Springfield Township Library Renovation: Contractor Inquiry List **Addendum #2**

SUBJECT: MEP Bid Addendum #1 Narrative

SPFLD00611 - LIBRARY BUILDING RENOVATIONS
70 POWELL ROAD, SPRINGFIELD, PA 19064

E200

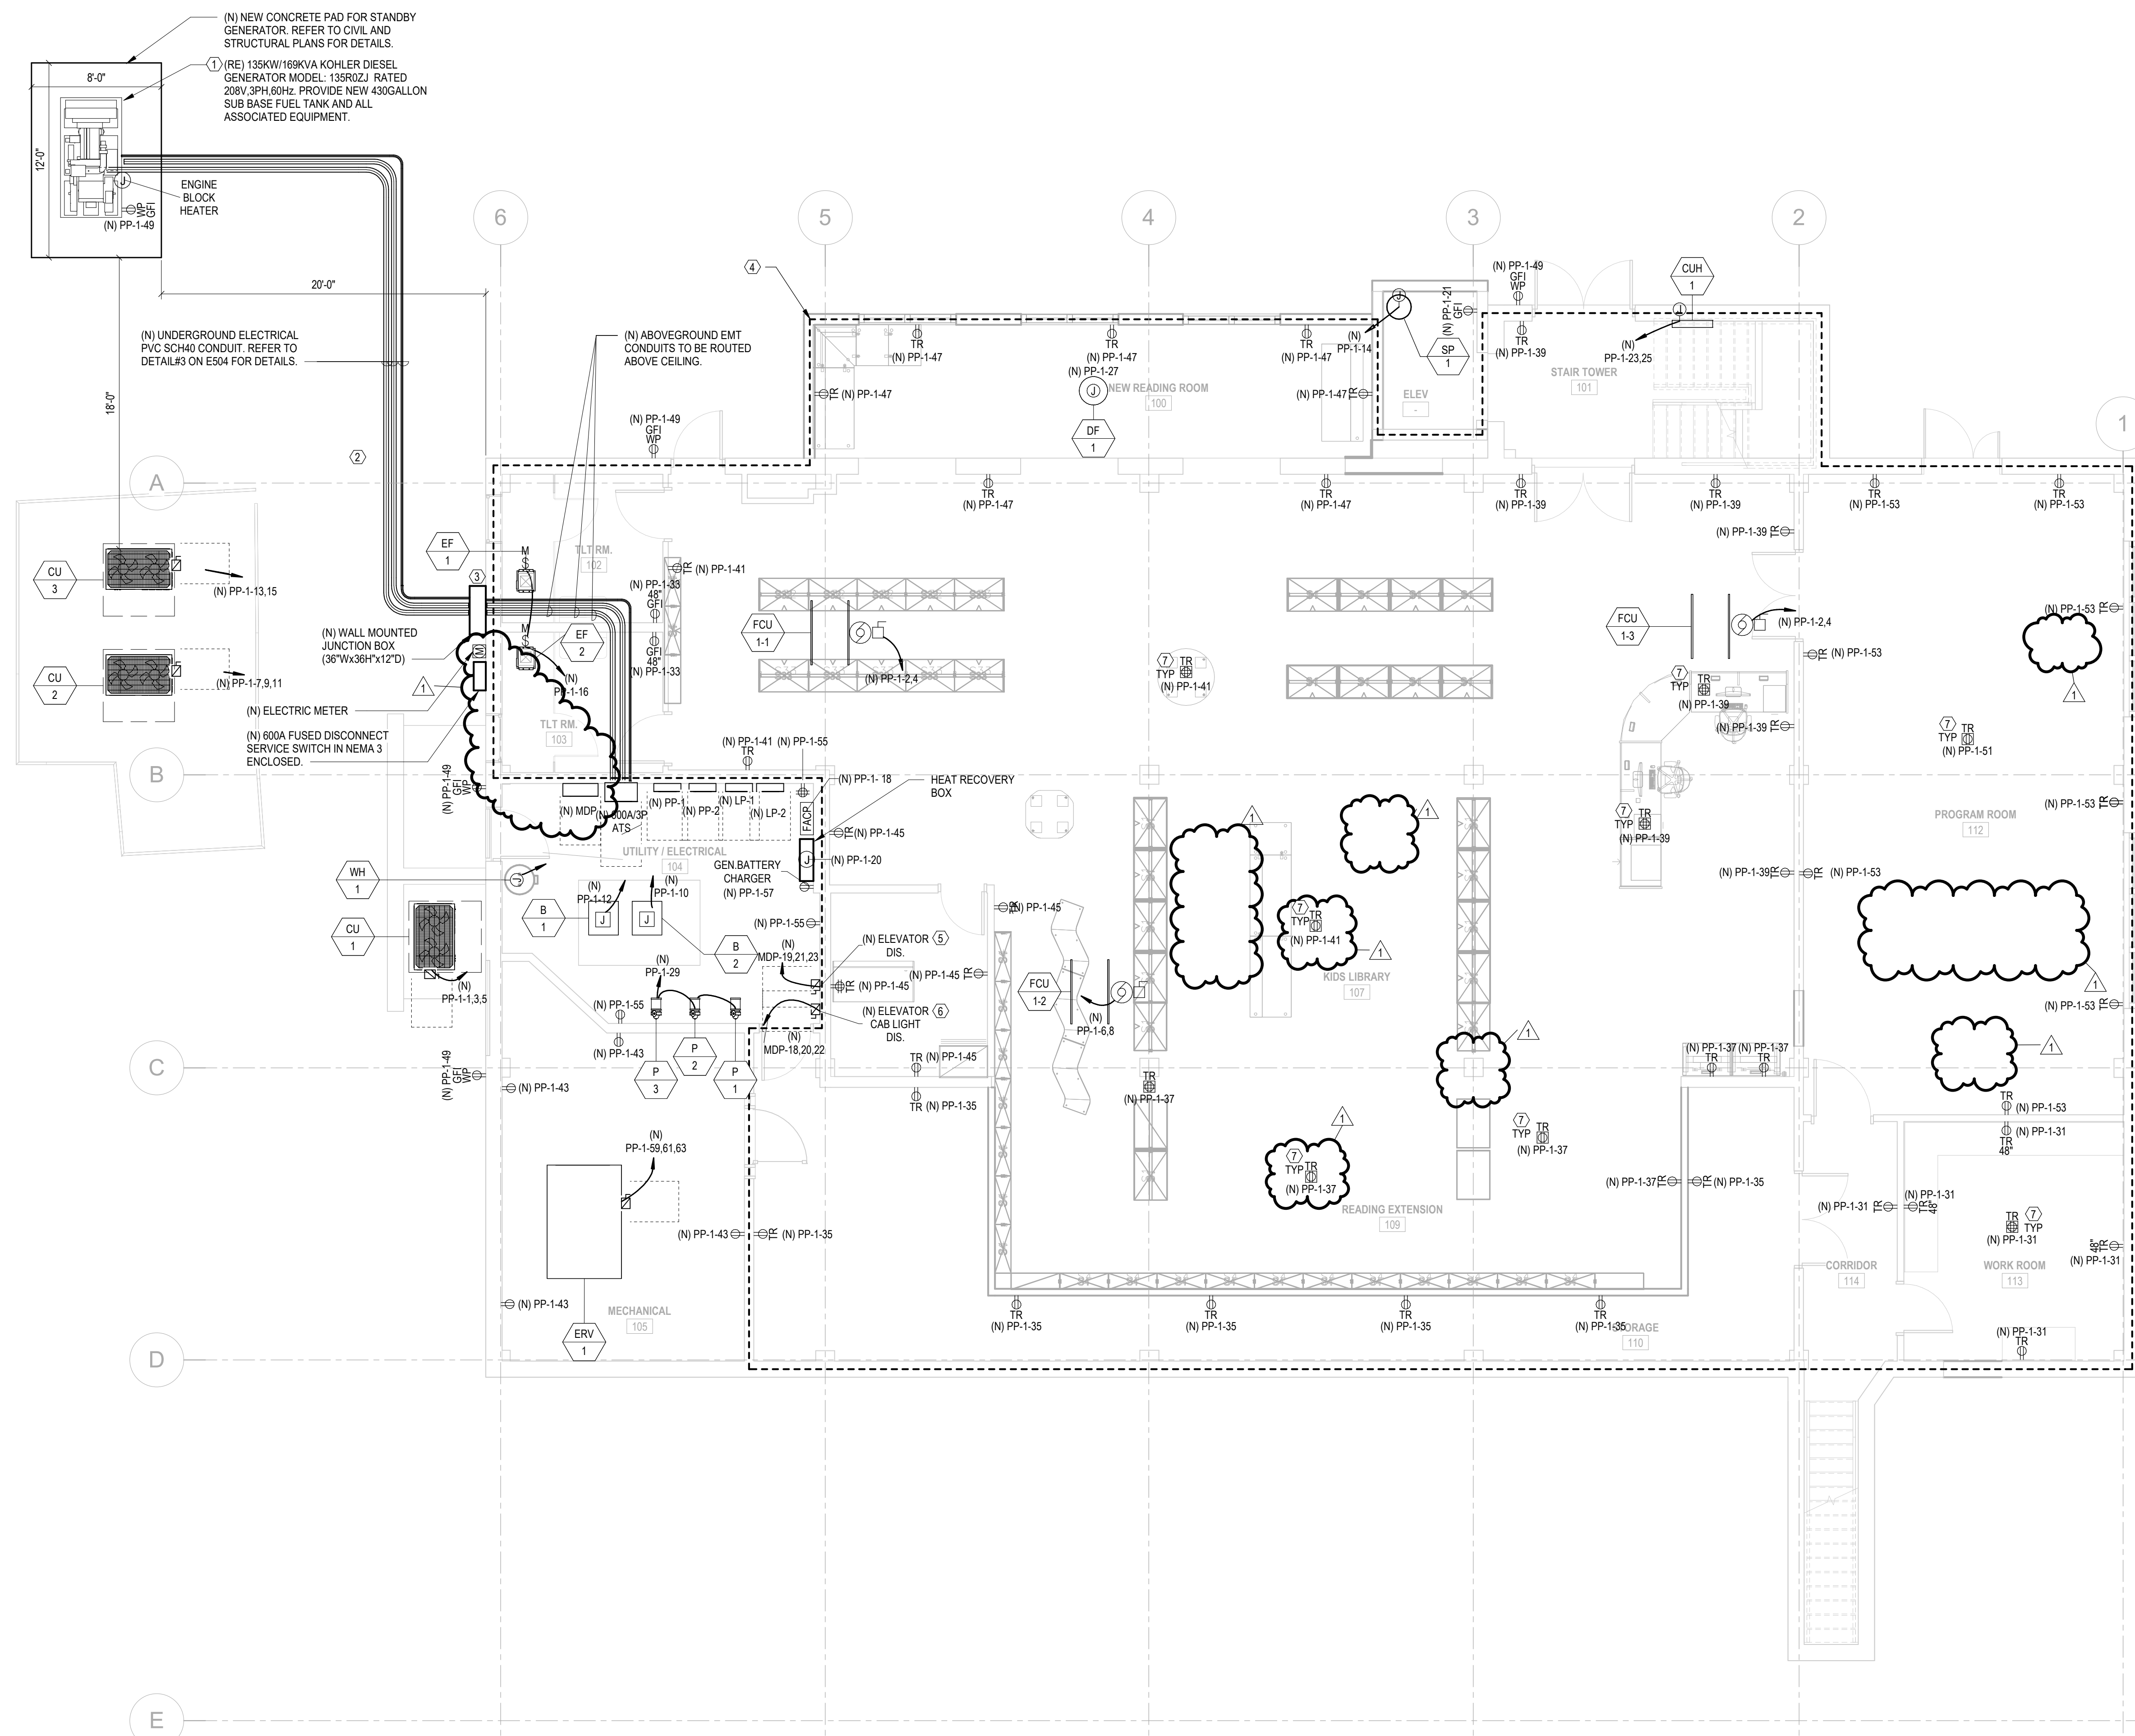
1. Revised and reduced the quantity of floor boxes and associated power connections based on the updated furniture layout.
2. Relocated the main service disconnecting means and electric meter from the electrical room to the building exterior.
3. Clarified the proposed PECO electrical service configuration, including the base-bid requirements for a new PECO-owned pad-mounted transformer and deduct-alternate requirements for connection to the existing pole-mounted transformer.

M200

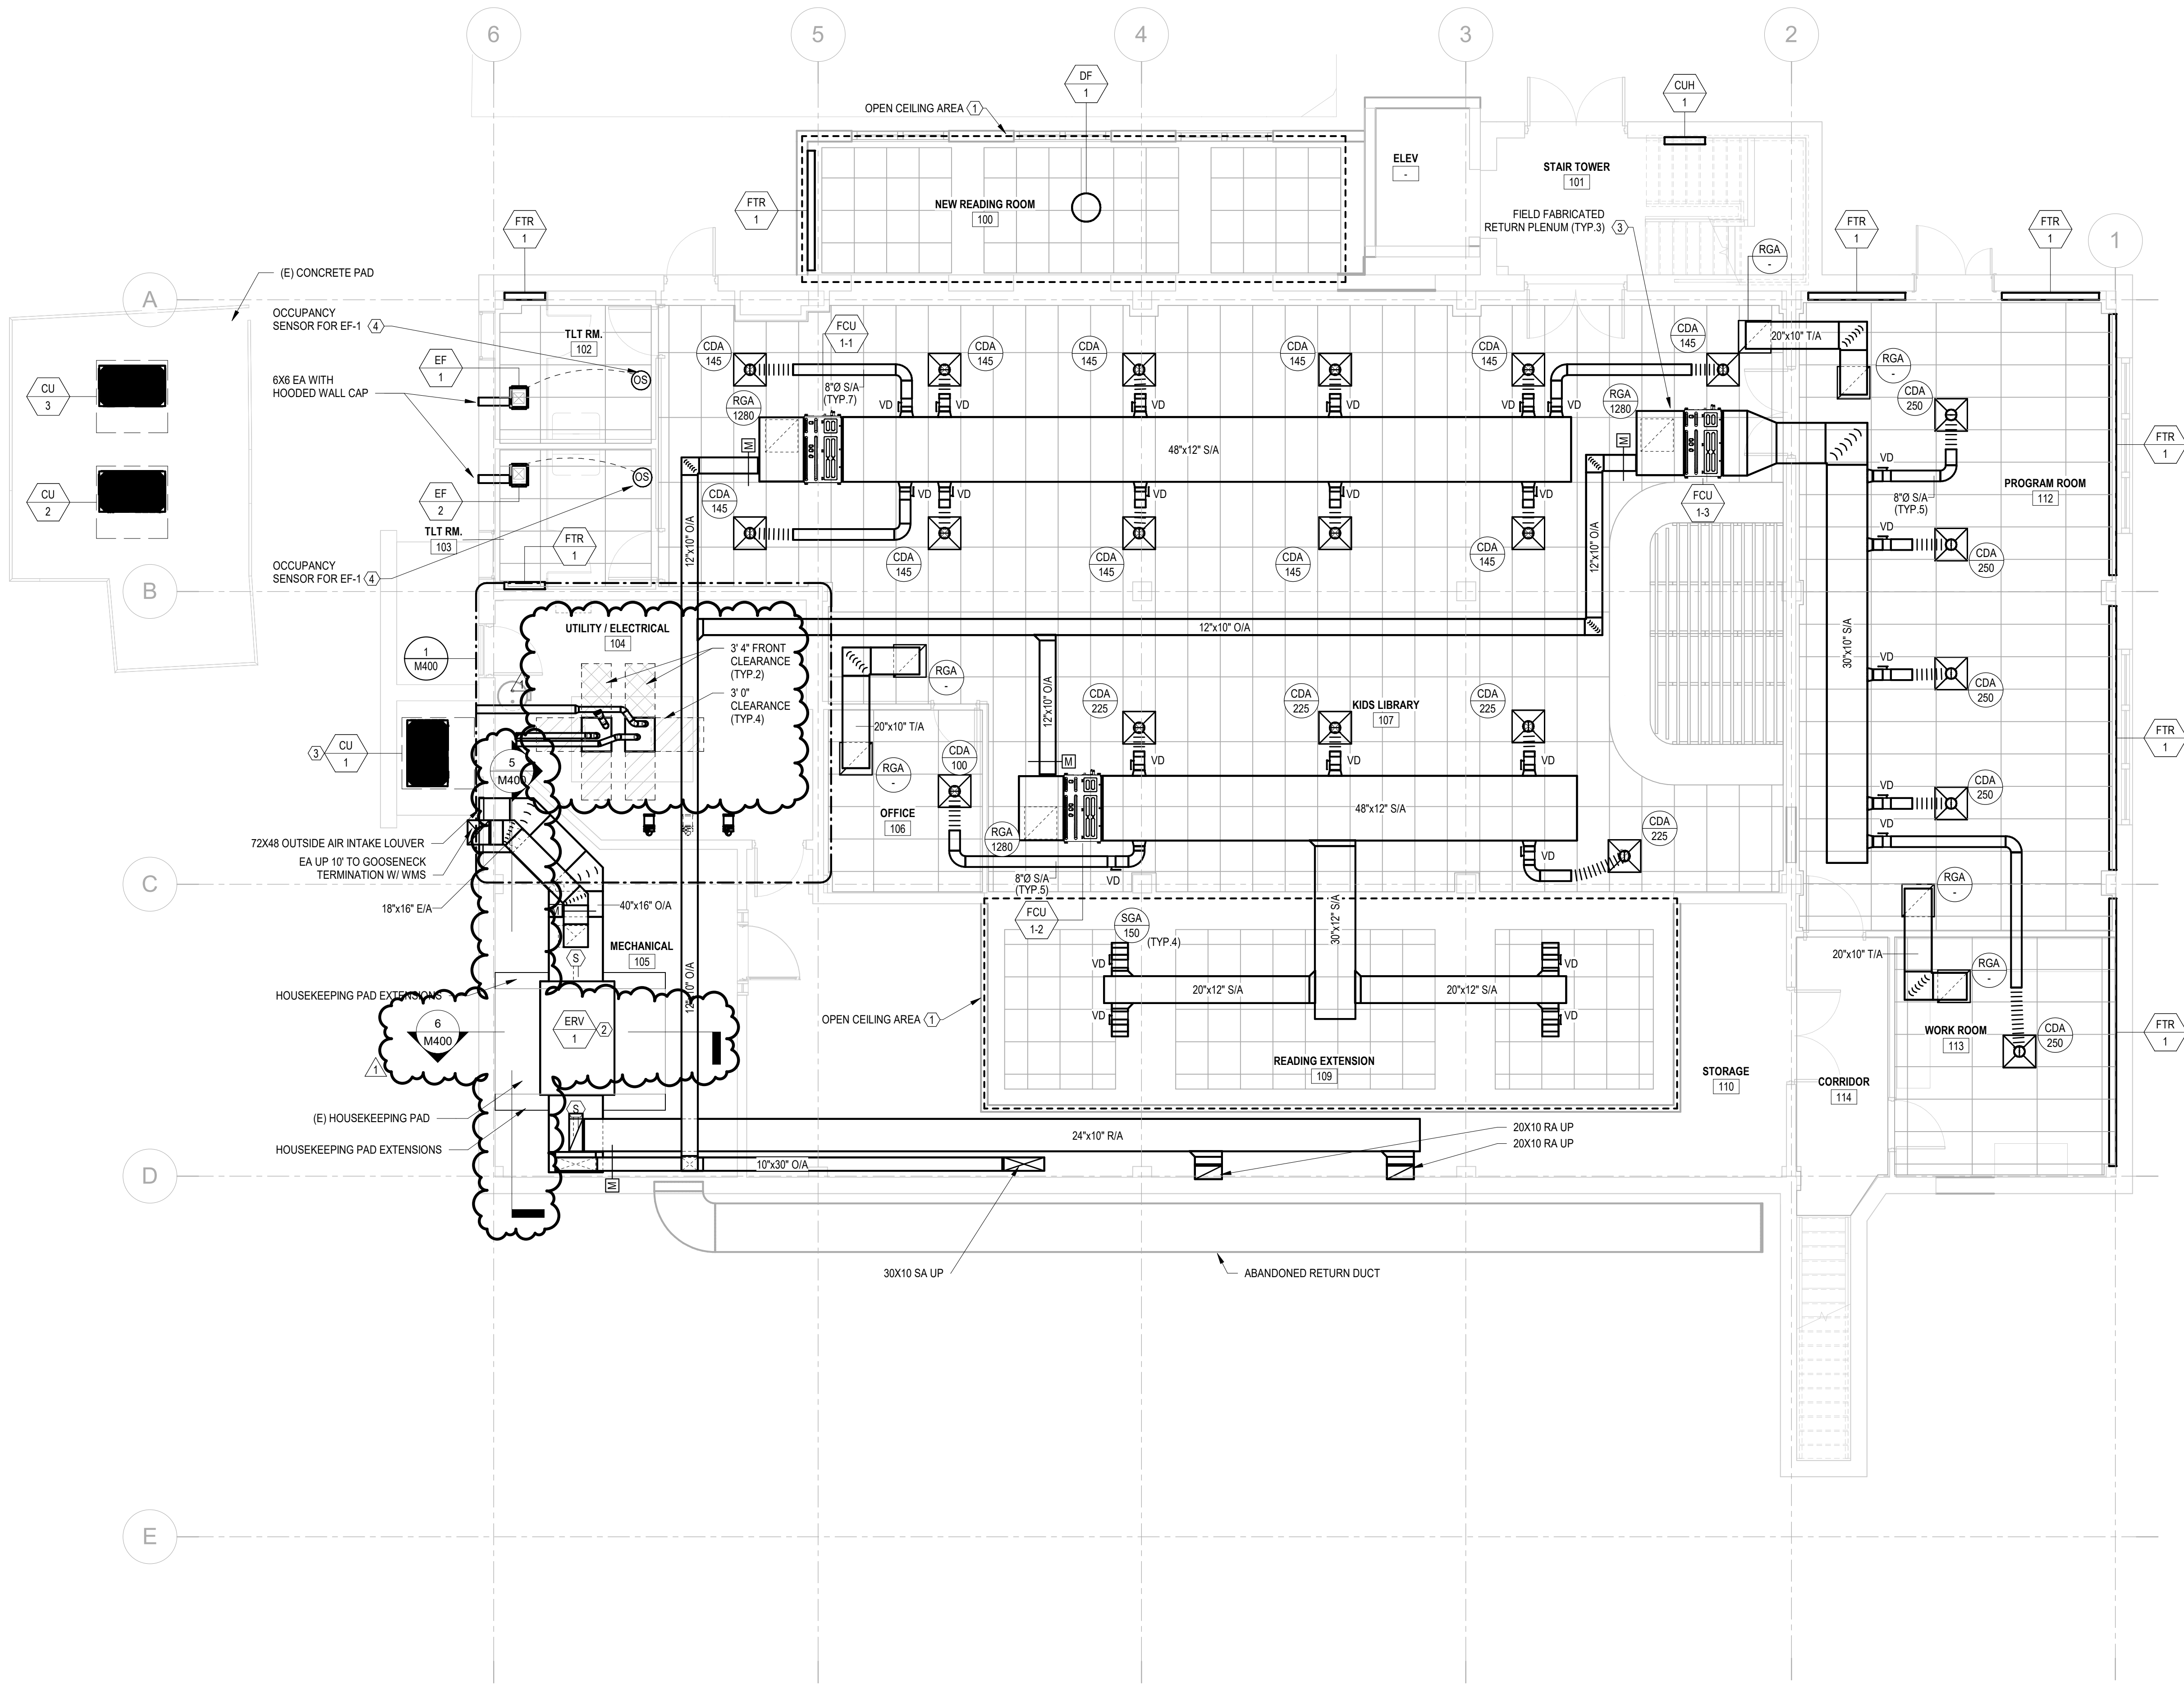
1. Clarified manufacture clearances for boilers.
2. Added sections to ERV-1 for clarity.

M201

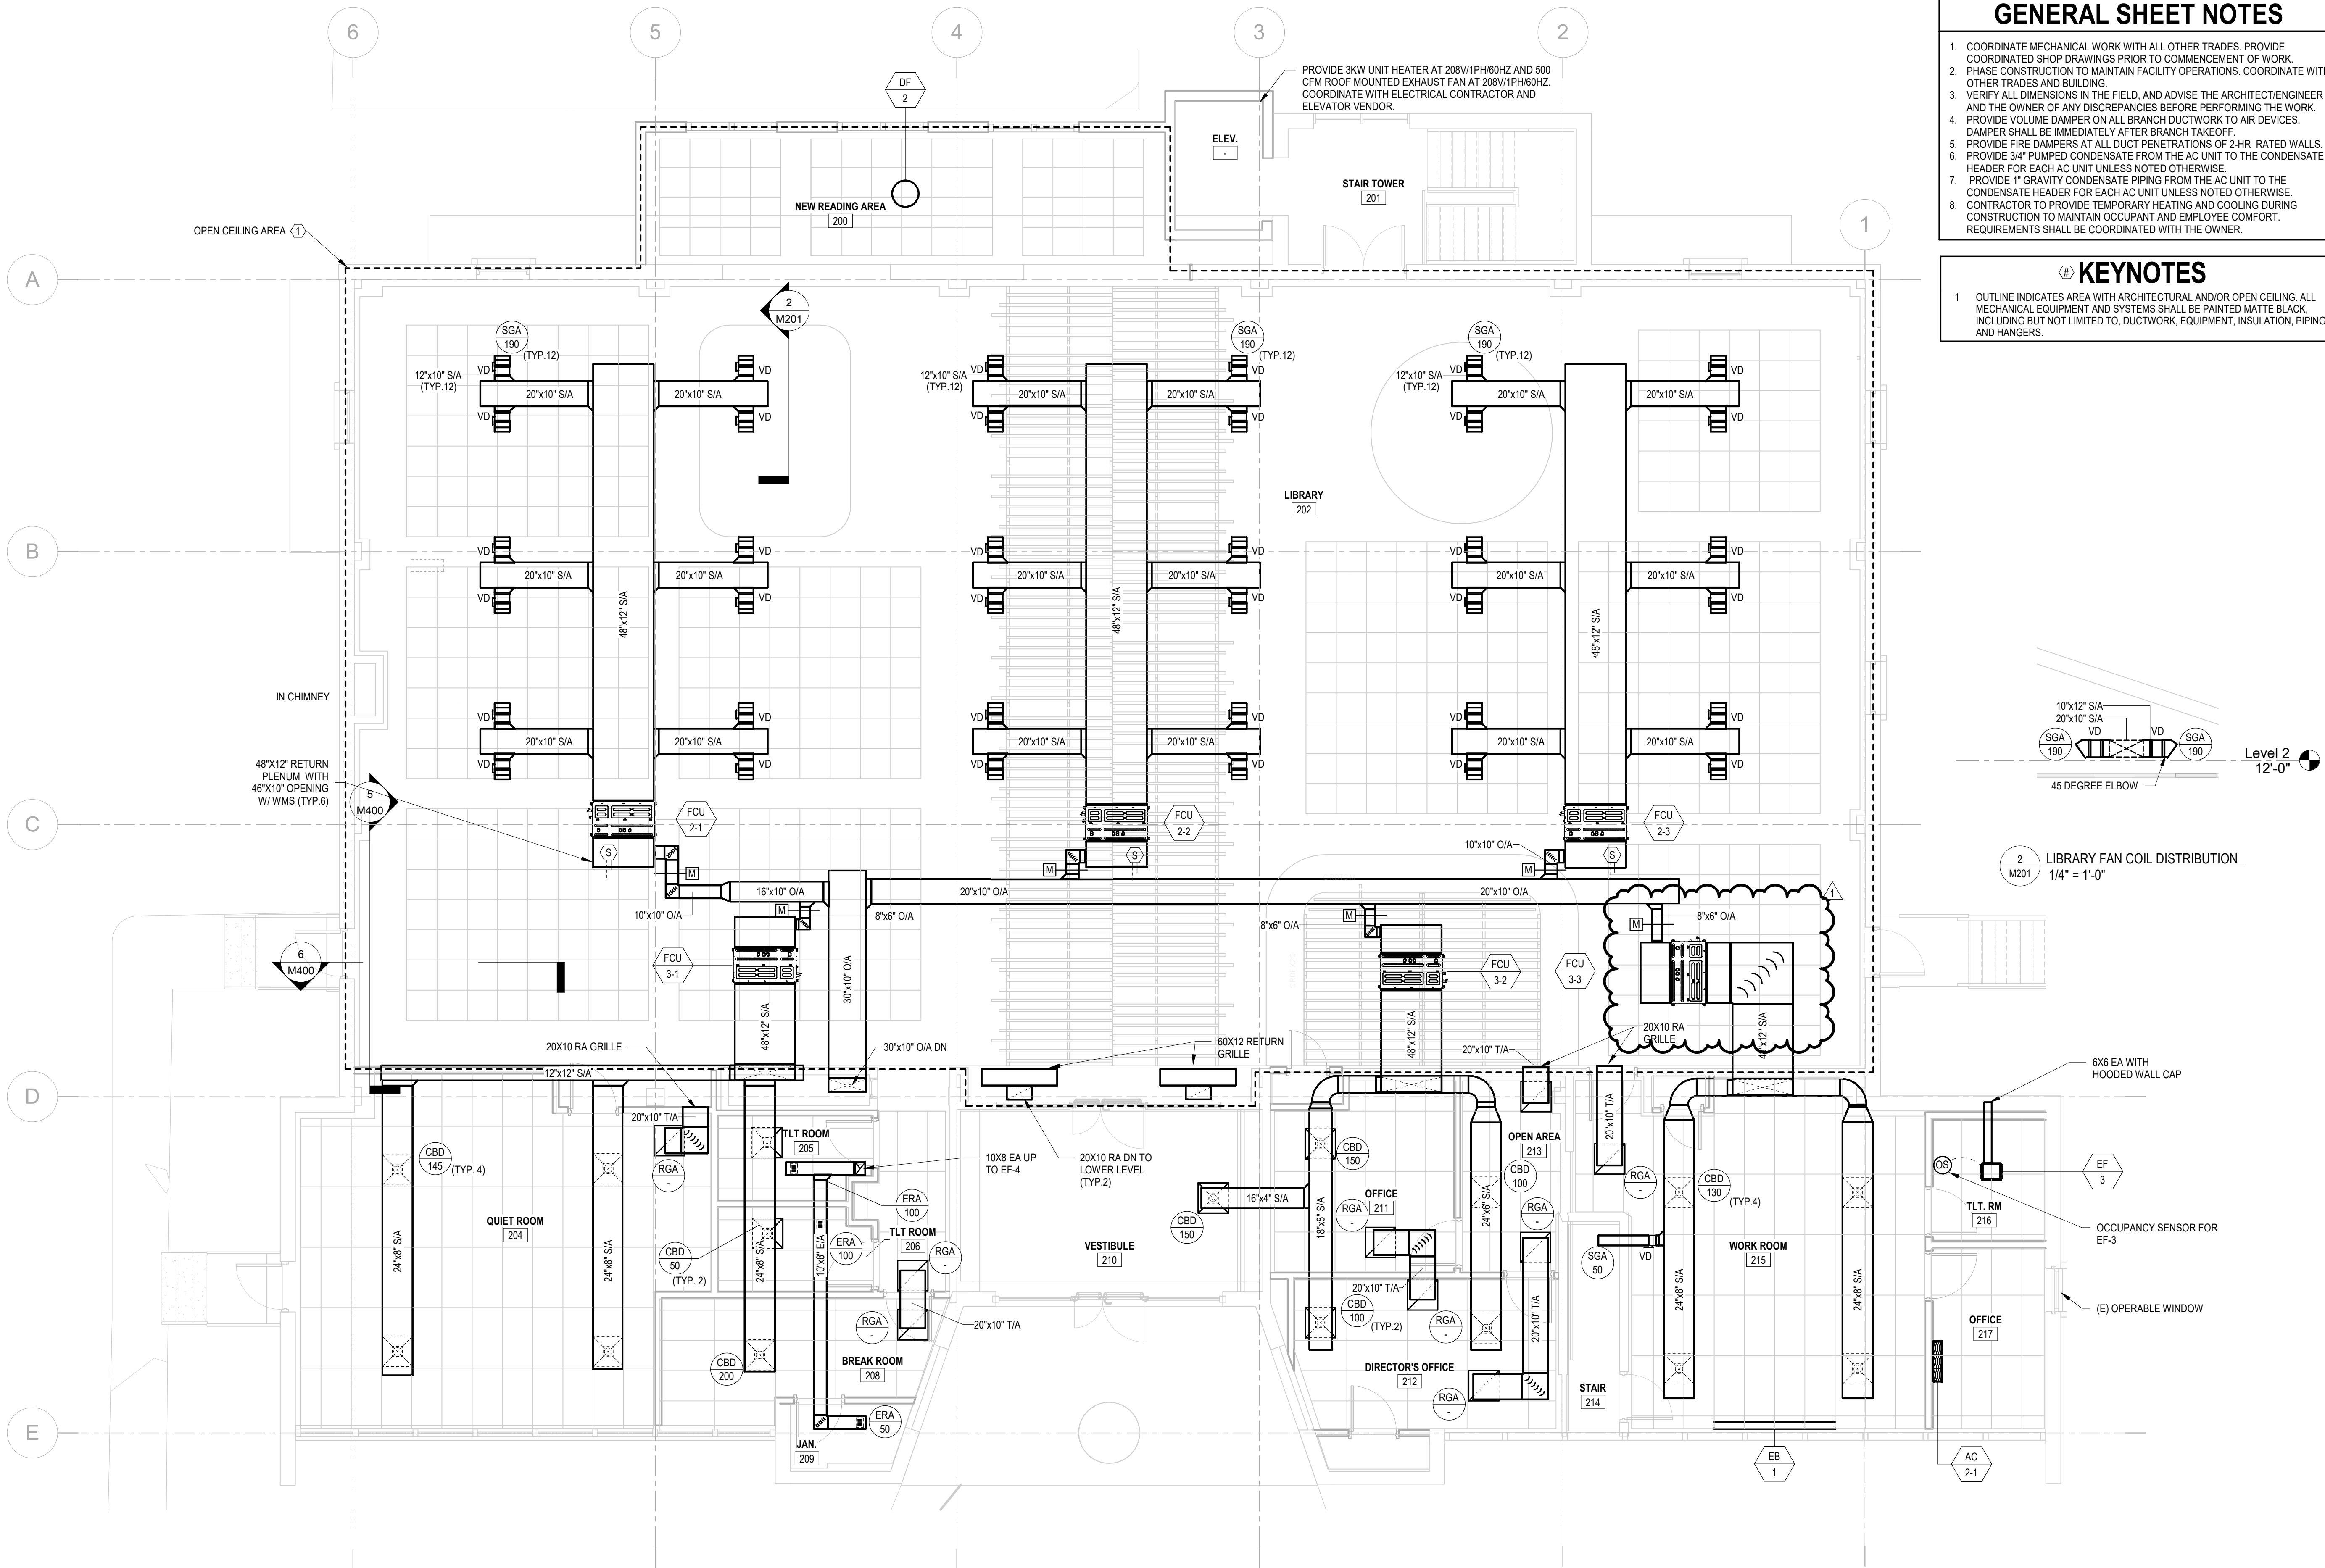
1. Re-oriented FCU 3-3 for constructability in field.
